STAFF REPORT
COMMUNITY DEVELOPMENT DEPARTMENT

HEARING DATE: December 1, 2020
 TO: Mayor & City Council
 FROM: Sonya Allen, Associate Planner
 208-884-5533
 SUBJECT: H-2020-0047
 Prescott Ridge – AZ, PP, PS, ALT
 LOCATION: South of W. Chinden Blvd. and east of N. McDermott Rd., in the North ½ of Section 28, Township 4N., Range 1W.
 (Parcels: S0428233640, R6991222210, S0428120950, S0428131315, S0428131200, S0428211102)

A. Master Plan Conceptual Rendering & Medical Campus Conceptual Development Plan - REVISED

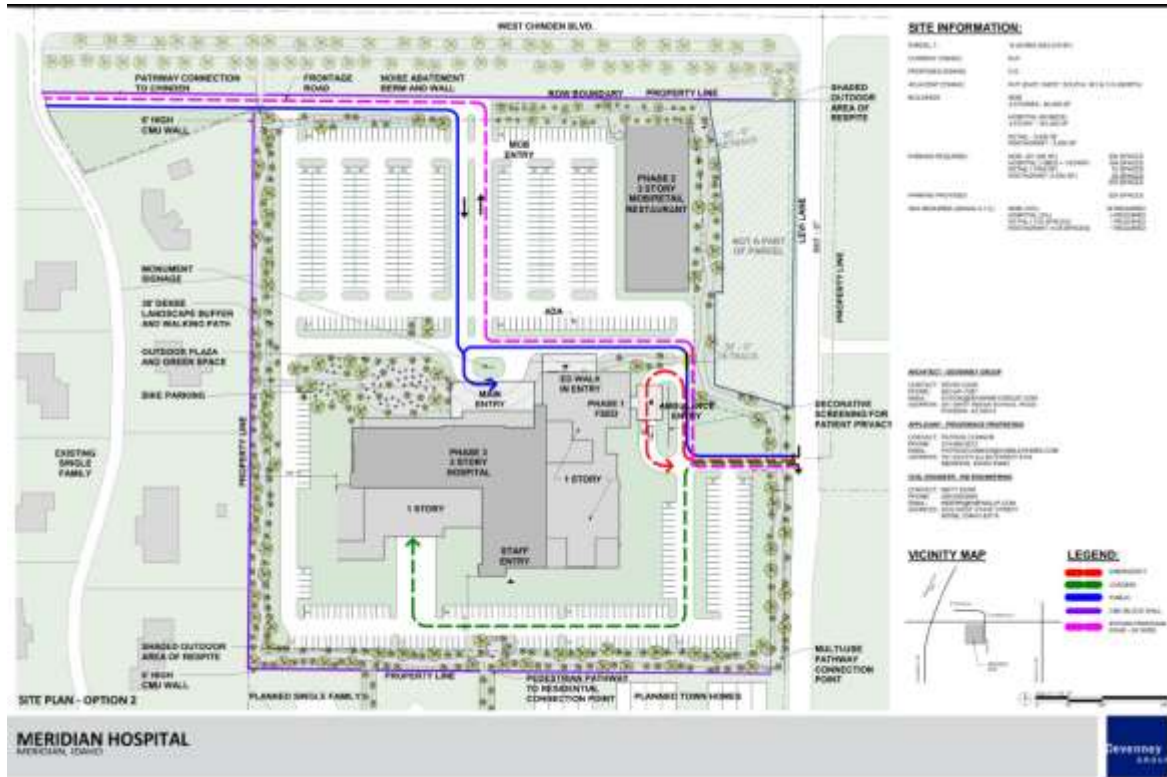
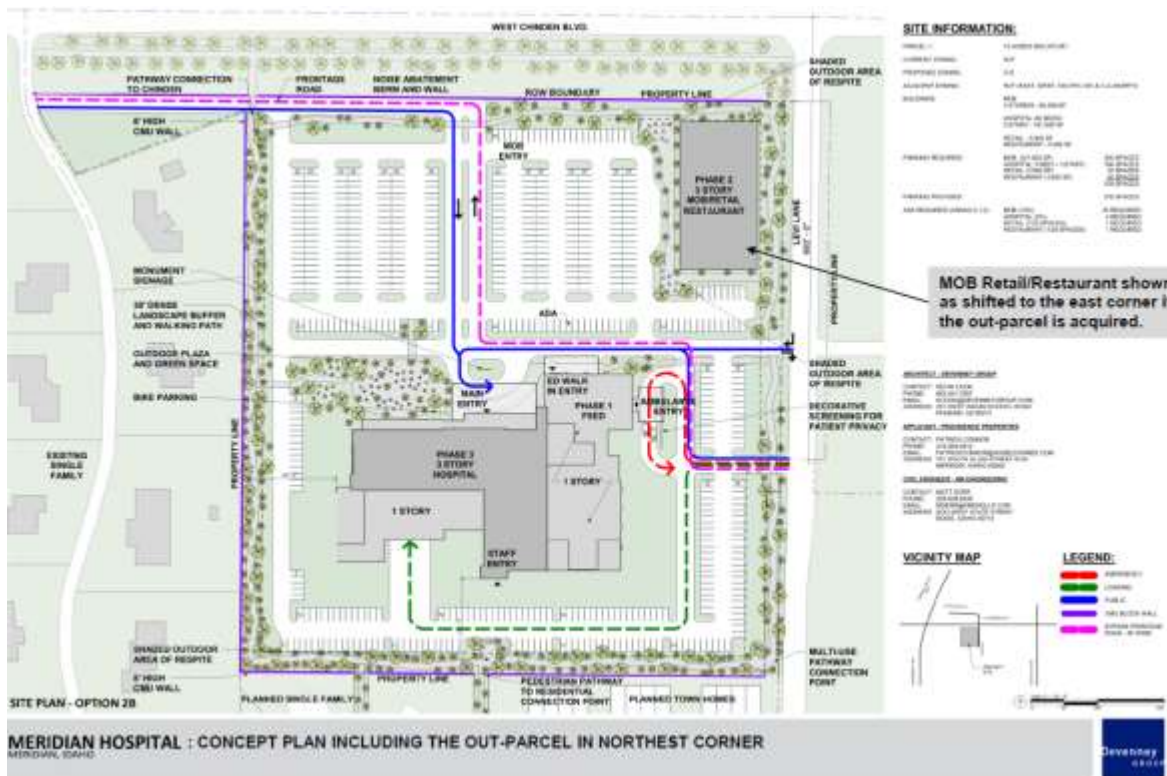
- b. Relocate the parking on the east side of the medical office building to the west side of the building and shift the building further to the east away from the adjacent residential properties (see revised concept plans in Section VIII.A);

~~The conceptual development plan for the commercial, C-G zoned portion of the site, shall be revised and submitted to the City Clerk at least 10 days prior to the City Council hearing to reflect conformance with the following guidelines in the Comprehensive Plan for Mixed Use developments:~~

- ~~• The buildings in the commercial C-G zoned portion of the development shall be arranged to create some form of common, usable area, such as a plaza or green space in accord with the mixed use guidelines in the Comprehensive Plan (pg. 3-13).~~

- ~~• Supportive and proportional public and/or quasi-public spaces and places including but not limited to parks, plazas, outdoor gathering areas, open space, libraries, and schools shall be provided in the Mixed Use designated portion of the site; outdoor seating areas at restaurants do not count (pg. 3-13). The school planned on the eastern portion of the annexation area does not satisfy this requirement as it is not part of the Mixed Use designated area.~~

- ~~• A commercial land use type shall be included on the plan in the MU-R designated area (includes retail, restaurants, etc.).~~

5. A frontage road parallel to W. Chinden Blvd./SH 20-26 shall be constructed as depicted on the conceptual development plan in Section VIII.A in accord with UDC 11-3H-4B.3e.

PHASING EXHIBIT

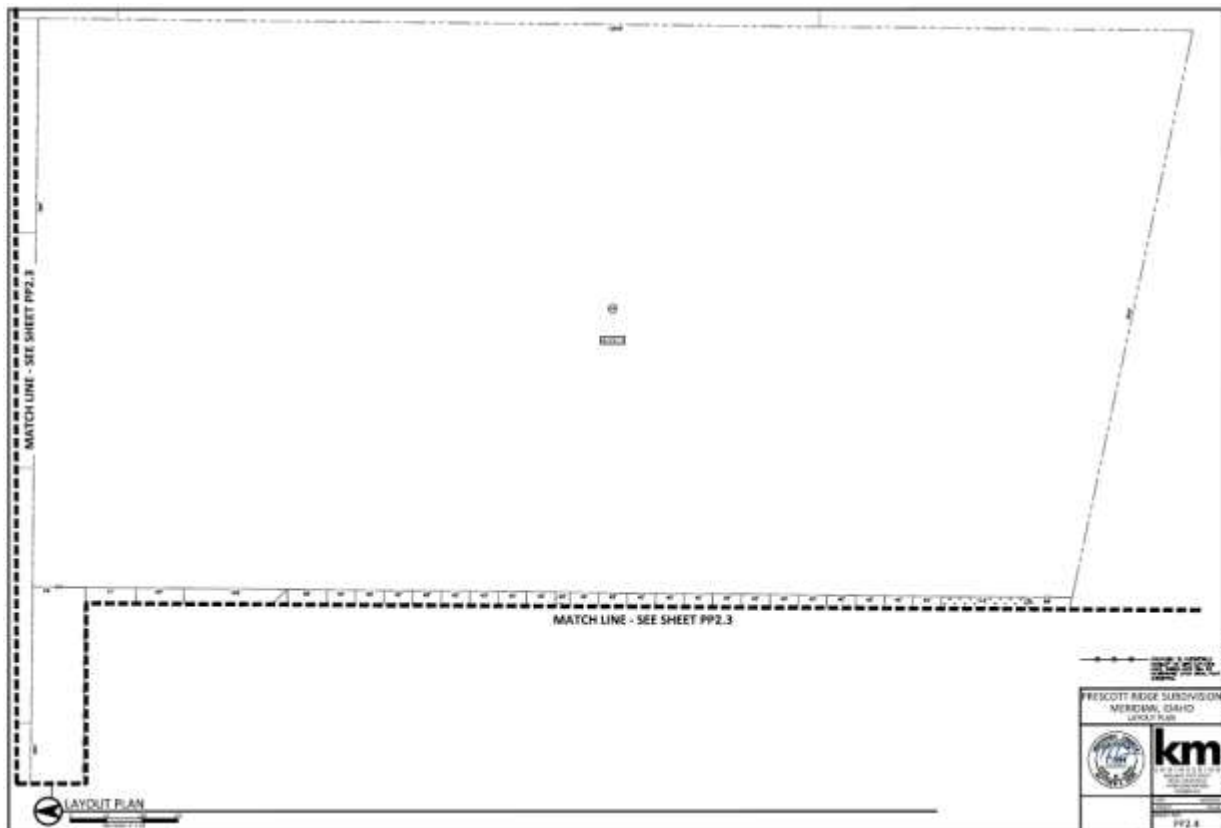
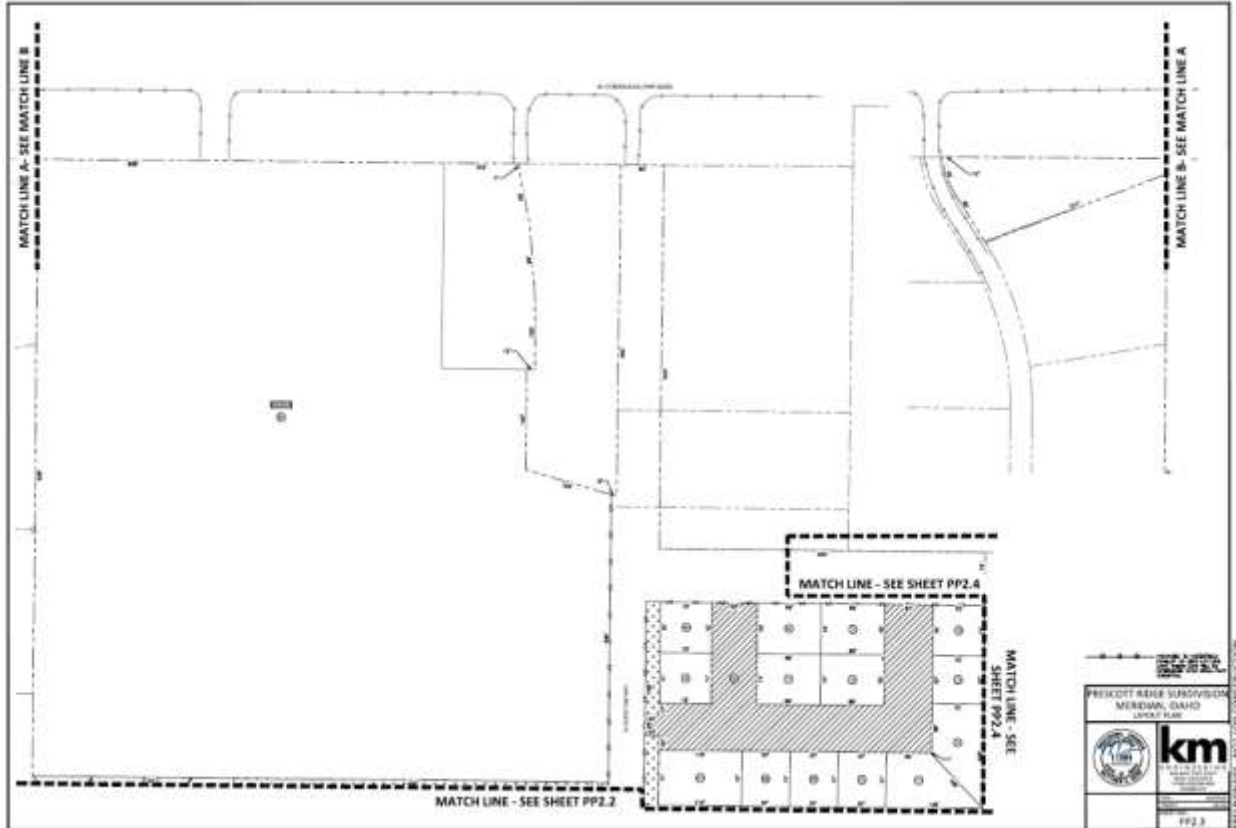
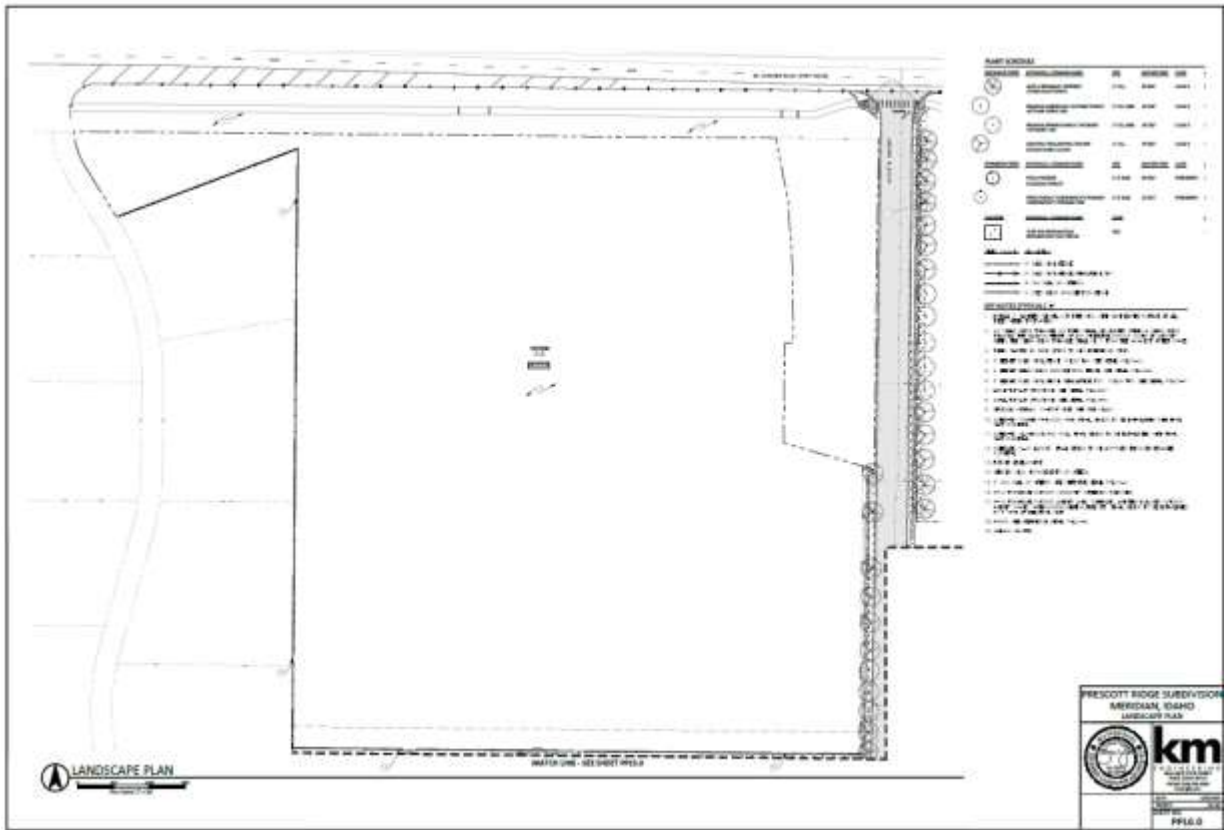
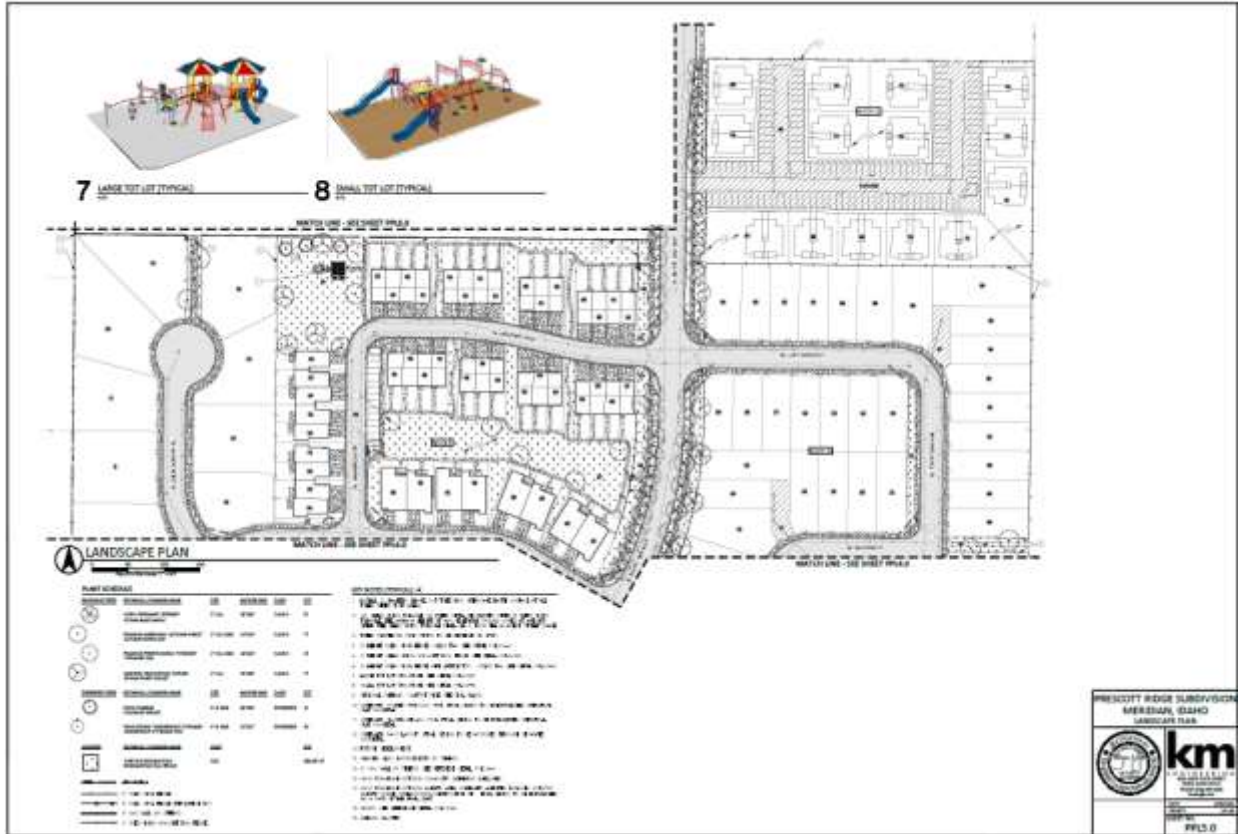
The commercial portion of the development (Lot 80, Block 8) and the school property (Lot 84, Block 12) are not included in the phasing plan as they are under separate ownership and will develop separately from the residential portion of the development. The Applicant estimates development of the hospital and medical campus will commence in 2021 at the earliest; and the school in 2023 at the earliest, assuming services are available.

E. Qualified Open Space Exhibit & Site Amenities (dated: 8/26/20 10/9/2020) – REVISÉD

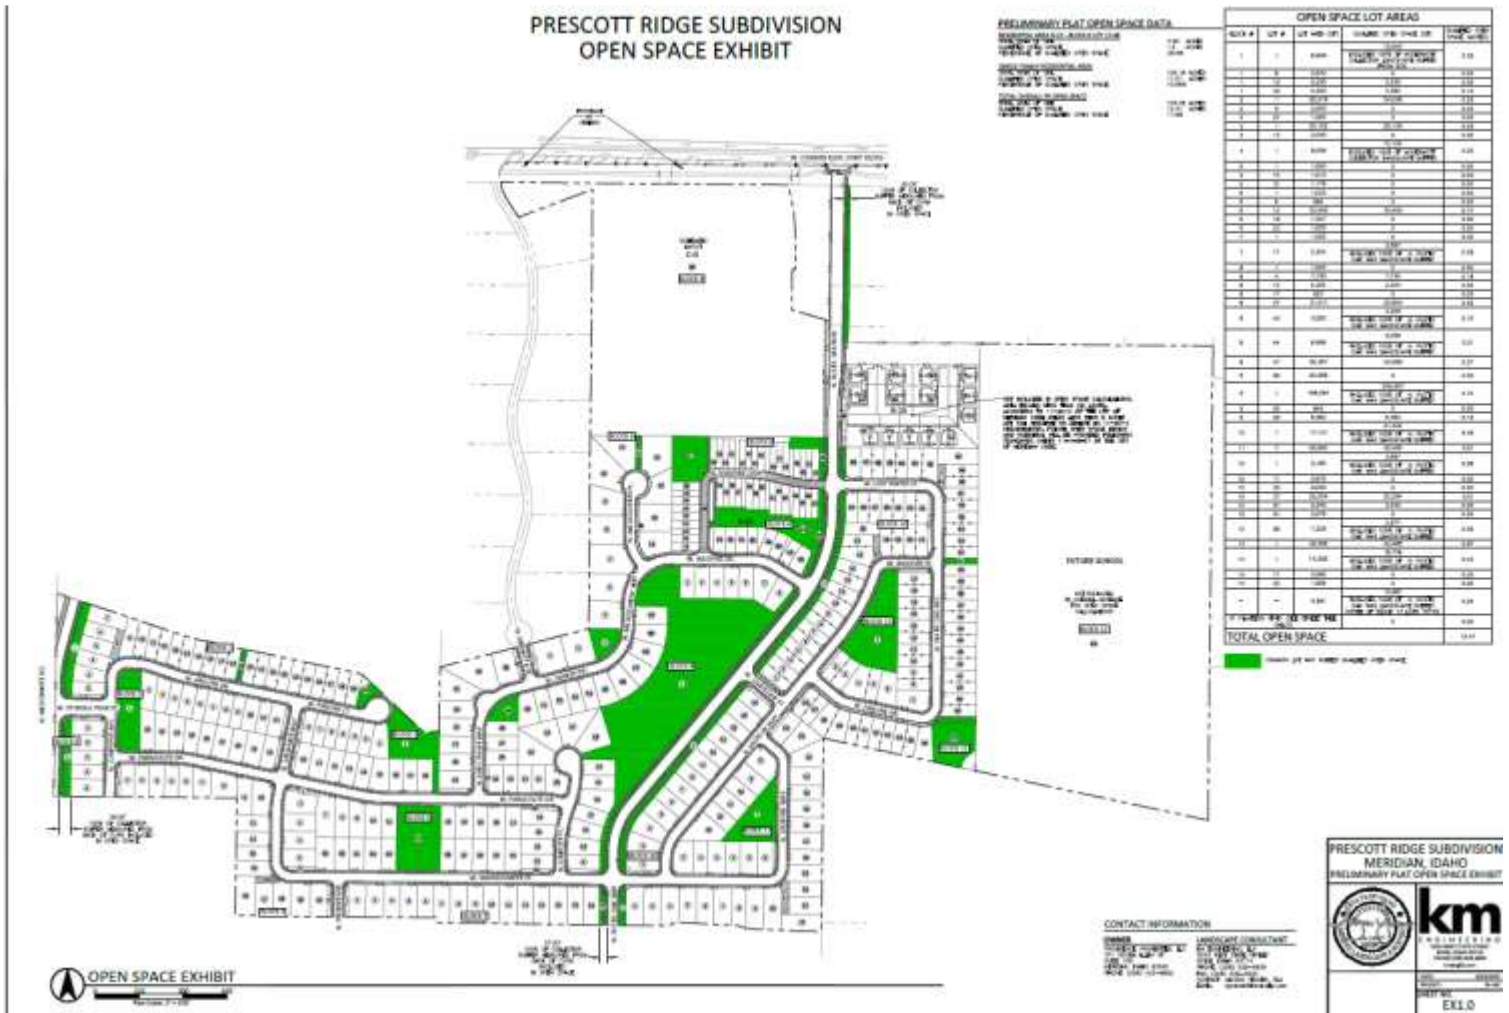
- k. If a dog park is proposed on Lot 1, Block 2, demonstrate compliance with the standards listed in UDC 11-3G-3C.1h.
 - l. Depict a small tot lot on Lot 12, Block 6 rather than a large tot lot, consistent with that shown on the site amenities plan.
